## Product Change Notice (PCN)

**PCN Number:** PCN-0374437R-01

Product(s) Affected: *CS-3603, CS-3606, CS-3612 & CS-3624*

Top	Side	Bottom
CS-36XX Old			
CS-36XX New

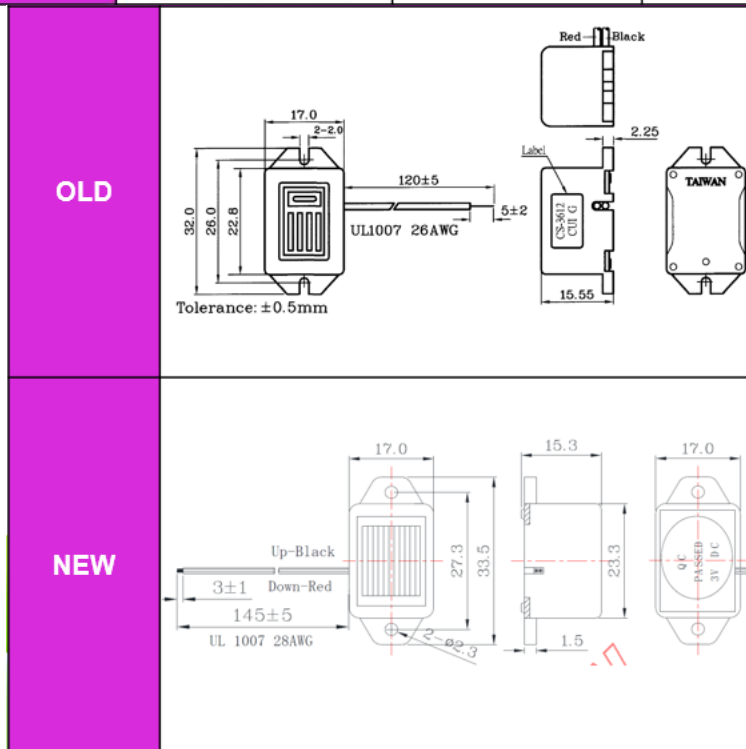
Description of Change: *Current consumption has decreased by 10mA on CS-3603 & CS-3606, it has increased by 5mA on CS-3612 & increased by 11mA on CS-3624. Operating voltage on CS-3624 has a new minimum of 18VDC. SPL has been increased by 3dB on CS-3603, CS-3606 & CS-3612. SPL has been increased by 2dB on CS-3624. Operating temperature on all four models has been widened to -30~70°C. Storage temperature on all four models has been shifted to -35~75°C. Some dimensional changes & elongated sound holes (shown in drawing below).*
